### **STARBUCKS EXPANSION WITH A DRIVE-THROUGH JSP 18-33**

Public hearing at the request of Ramco West Oaks II LLC for JSP 18-33 Starbucks Expansion with a Drive-Through for Planning Commission’s recommendation to the City Council for approval of Special Land Use, Preliminary Site Plan with a PD-2 option and Storm Water Management plan. The subject property is located on the west side of Novi Road south of Twelve Mile Road in West Oaks Shopping Center in Section 15. The applicant is proposing an expansion of the existing Starbucks coffee shop with an addition of a drive-thru facility.

## PLANNING REVIEW

Preliminary Site Plan with a Special Land Use and Final Site Plan

DRAWN BY: EM/JC  
CHECKED BY: EM  
PROJECT MANAGER: MMC  
JOB #: 17002685  
FILE CODE: 0P  
SHEET NO. C09

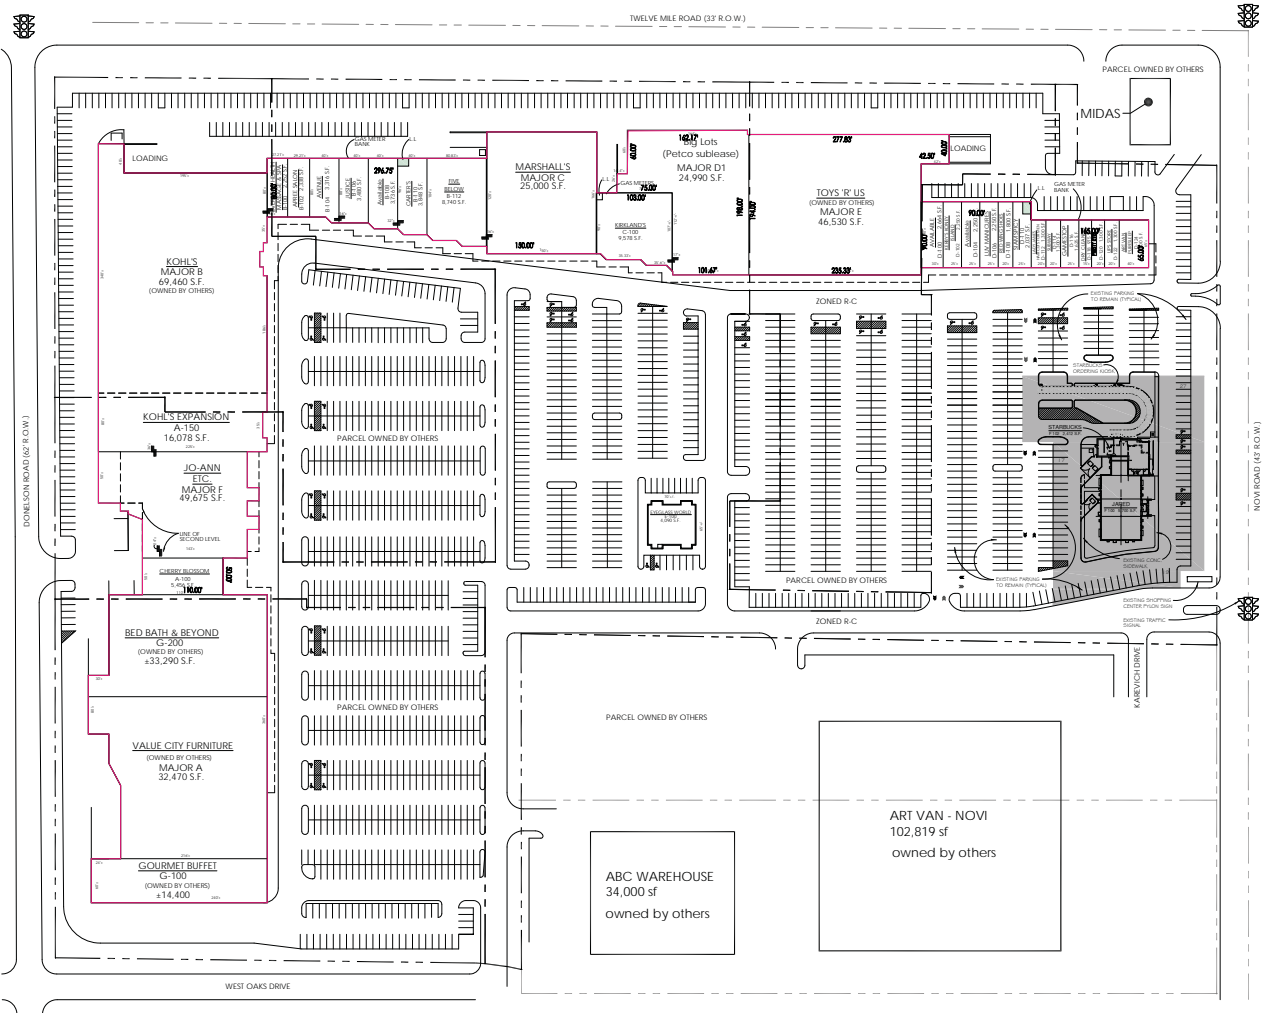
Item	Required	Proposed	Meets Code	Comments
(LDM 2.e.(1))		on Sheet C05		
<b>Snow deposit</b> (LDM.2.g.)	Show snow deposit areas on plan	Yes	Yes	
<b>LANDSCAPING REQUIREMENTS</b>				
<b>Parking Area Landscape Requirements LDM 1.c. &amp; Calculations (LDM 2.o.)</b>				
<b>General requirements</b> (LDM 1.c)	<ul style="list-style-type: none"> <li>▪ Clear sight distance within parking islands</li> <li>▪ No evergreen trees</li> </ul>	Yes	Yes	
<b>Name, type and number of ground cover</b> (LDM 1.c.(5))	As proposed on planting islands	Yes	Yes	<b>Please provide a legend for all hatching or use callouts to make clear what the ground treatments are.</b>
<b>General (Zoning Sec 5.5.3.C.ii)</b>				
<b>Parking lot Islands</b> (a, b. i)	<ul style="list-style-type: none"> <li>▪ A minimum of 200 SF to qualify</li> <li>▪ A minimum of 200sf unpaved area per tree planted in an island</li> <li>▪ 6" curbs</li> <li>▪ Islands minimum width 10' BOC to BOC</li> </ul>	Yes	TBD	<b>Please dimension widths of islands in linear feet.</b>

<b>Island widths provided. Refer to sheet C09.</b>				
<b>Curbs and Parking stall reduction</b> (c)	Parking stall can be reduced to 17' and the curb to 4" adjacent to a sidewalk of minimum 7 ft.	Endcap islands are provided north and south of drive-thru.	TBD	It appears that the parking bay east of the new northern island will be needed to be provided with endcap island too.
<b>Contiguous space limit</b> (i)	Maximum of 15 contiguous spaces	Parking bays are not enlarged by the project.	Yes	See above.
<b>Plantings around Fire Hydrant</b> (d)	No plantings with matured height greater than 12' within 10 ft. of fire hydrants	All trees are 10 feet from hydrants.	TBD	<ol style="list-style-type: none"> <li>1. Trees should also be 5 feet from underground lines.</li> <li>2. <b>Please show all utilities on landscape plan and adjust lines/trees to avoid conflicts.</b></li> </ol>
<b>Utility information has been provided on sheet C09.</b>

Deciduous trees provided in new endcaps. Refer to sheet C09.

Perimeter calculation and basis provided on sheet C09.

Screening added as requested. Refer to sheet C09.

**REVISED SITE PLAN**  
**(E-mail dated 12-17-18)**

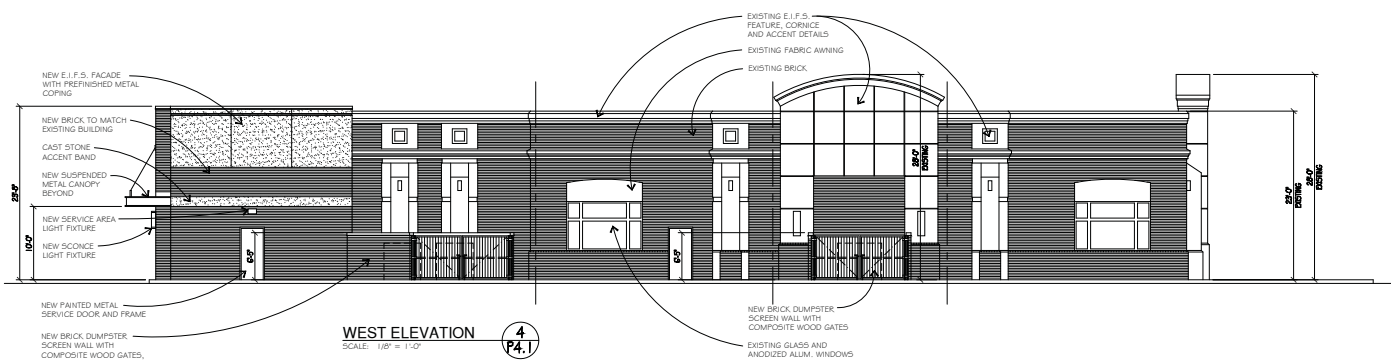
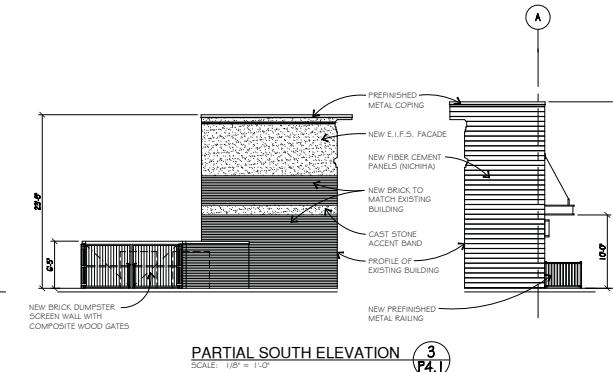
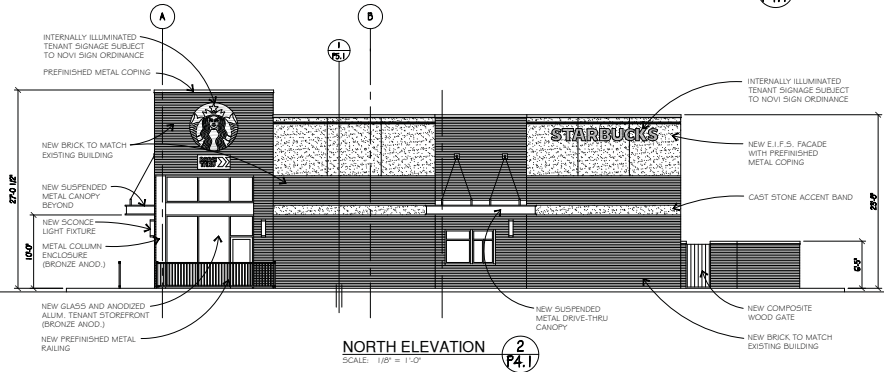
1. **Drive-through Lanes Separation (Sec. 5.3.11.A,C)**: Staff requested additional pavement at the U-turn to provide some additional space for maneuverability. The additional pavement is supposed to be striped. **Please provide a revised layout in PDF format prior to Planning Commission meeting.**

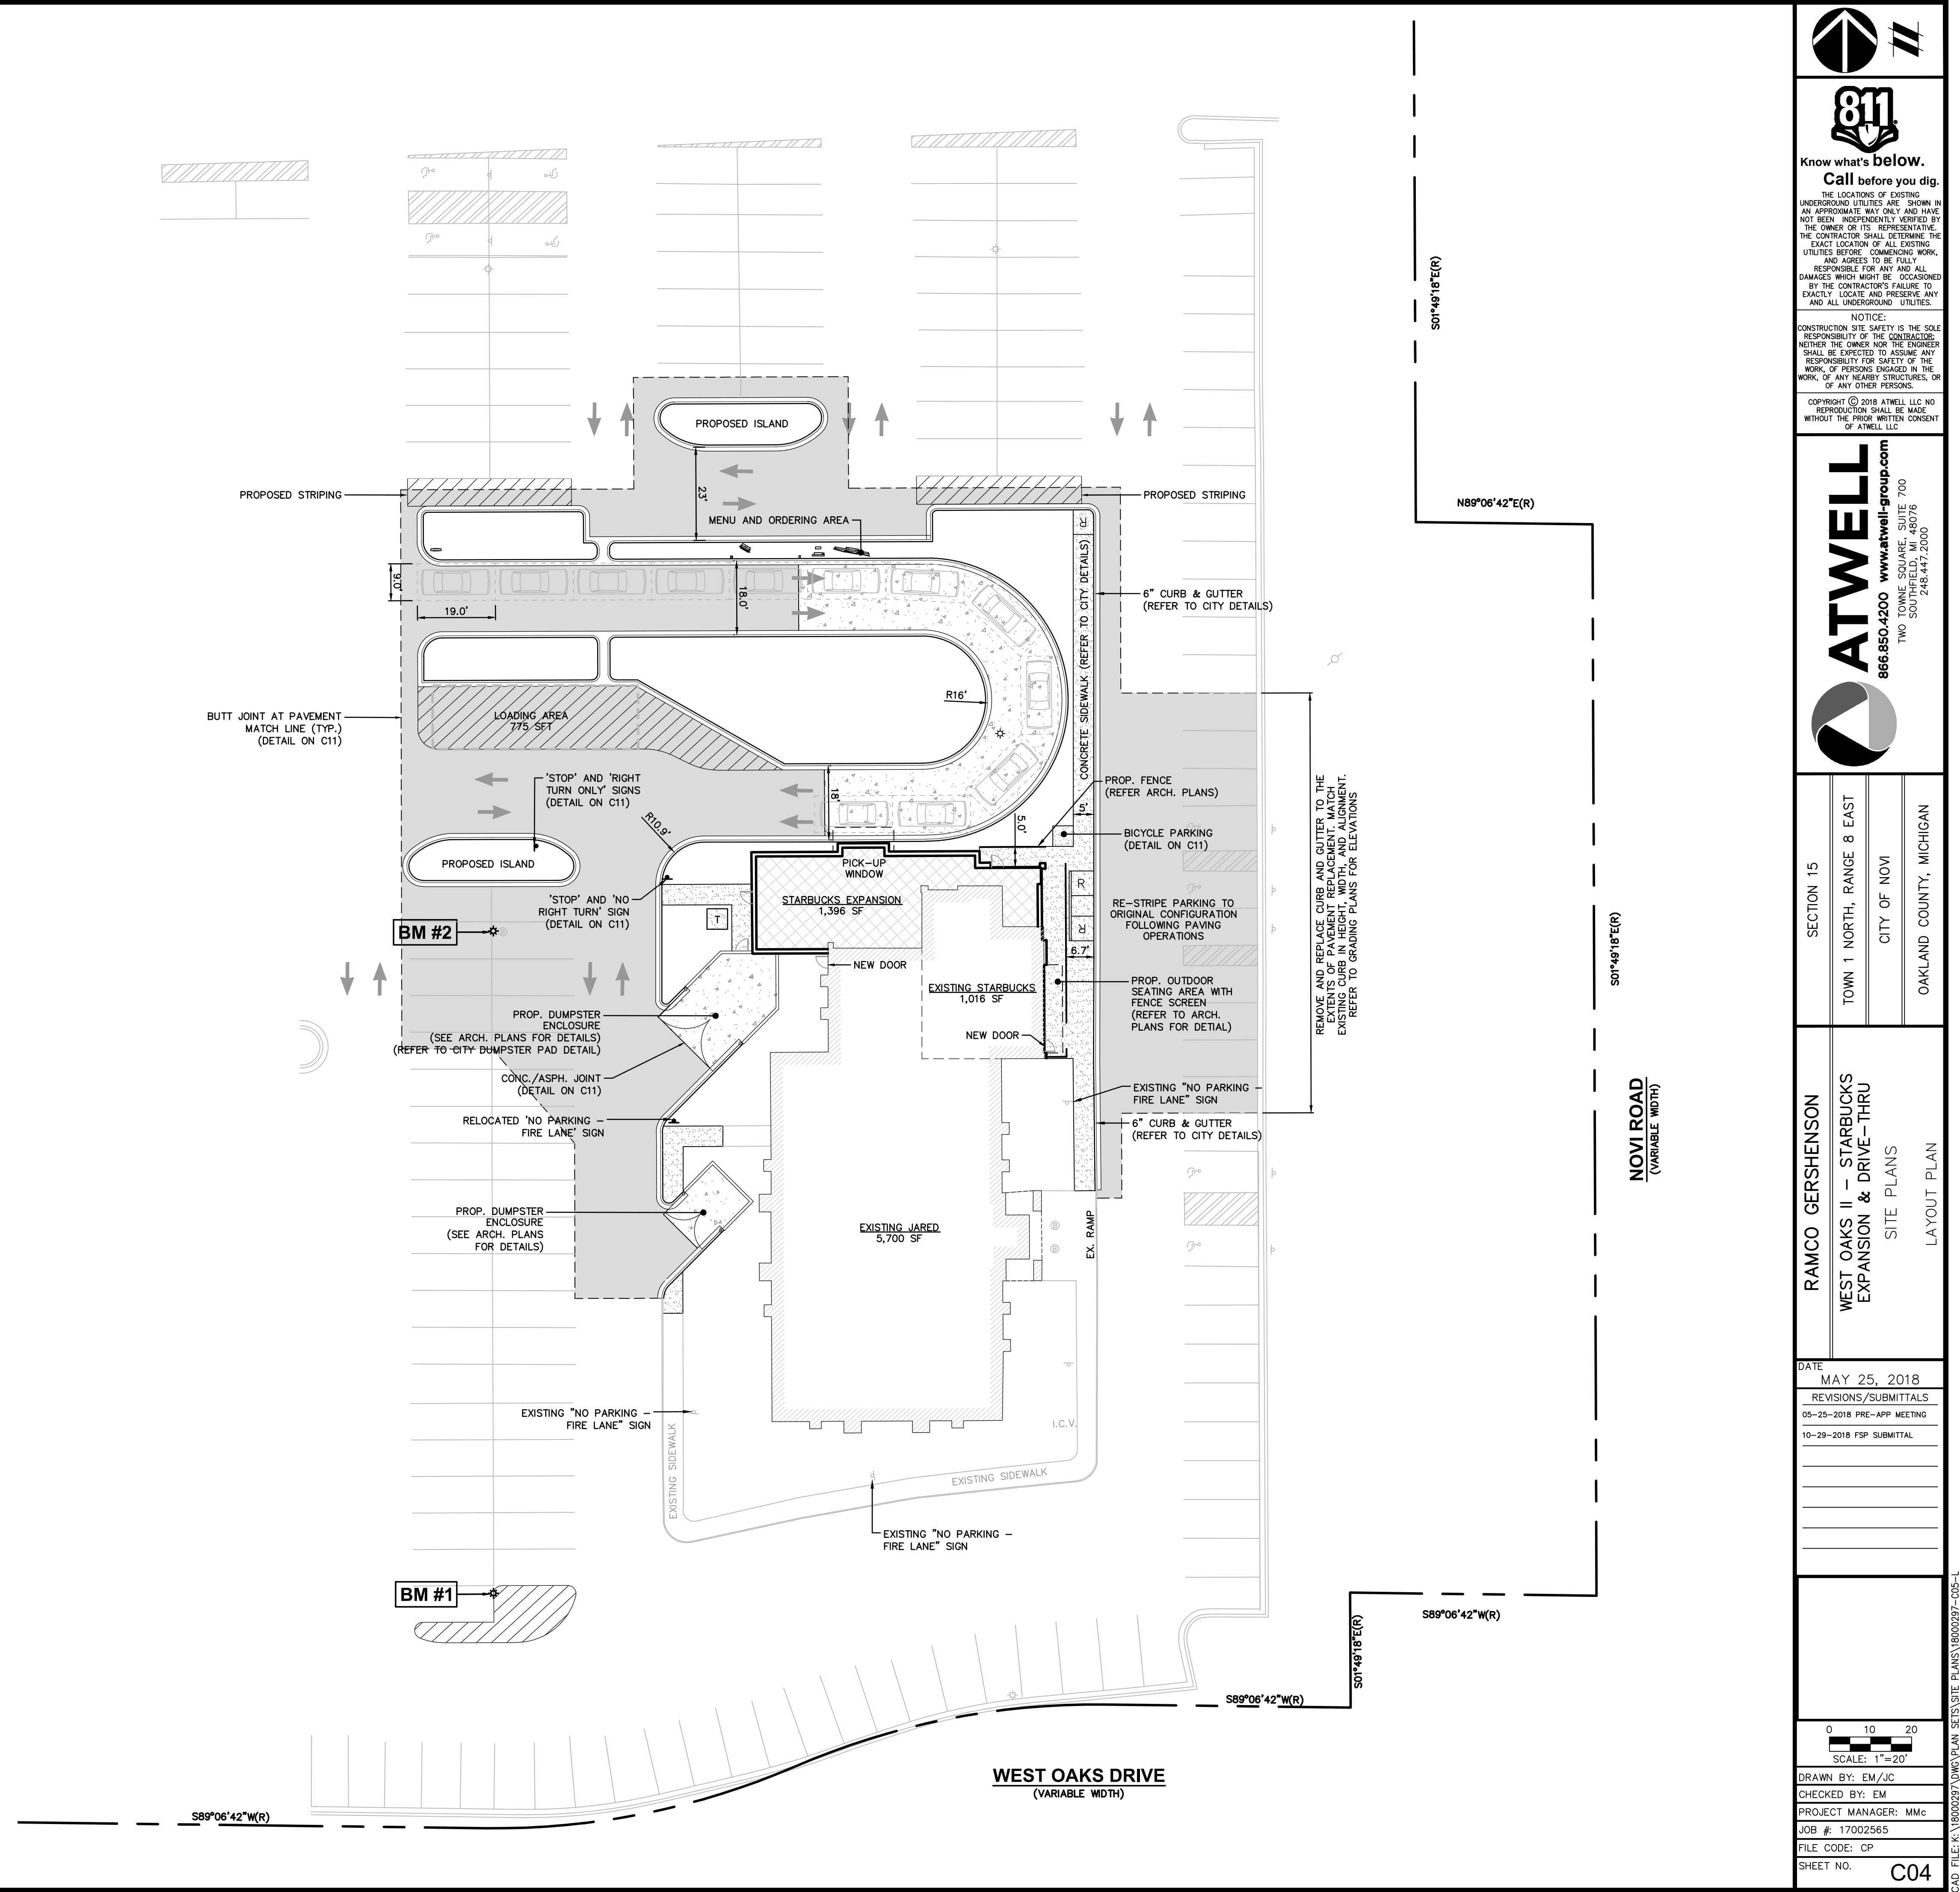
- c. The applicant should indicate which of the traffic flow arrows shown on sheet C04 are proposed pavement markings. Arrows should be hollow for the purposes of showing traffic flow, and solid if proposed to be pavement markings.

- i. The applicant has indicated that the drive-thru lane and bypass lane each have an effective width of nine feet.
  - ii. The applicant should indicate the centerline radius of the drive-thru lane. City Zoning Ordinance requires a 25 foot centerline radius (Section 5.11.F) 25' radius dimension provided on sheet C04.

The drive-thru layout has been modified to allow for a larger turning area as suggested. Refer to sheet C04.

Aisle has been increased to 24'. Refer to sheet C04.

Dimension of the raised islands have been provided on sheet C04. The raised islands are in compliance with the ordinance.
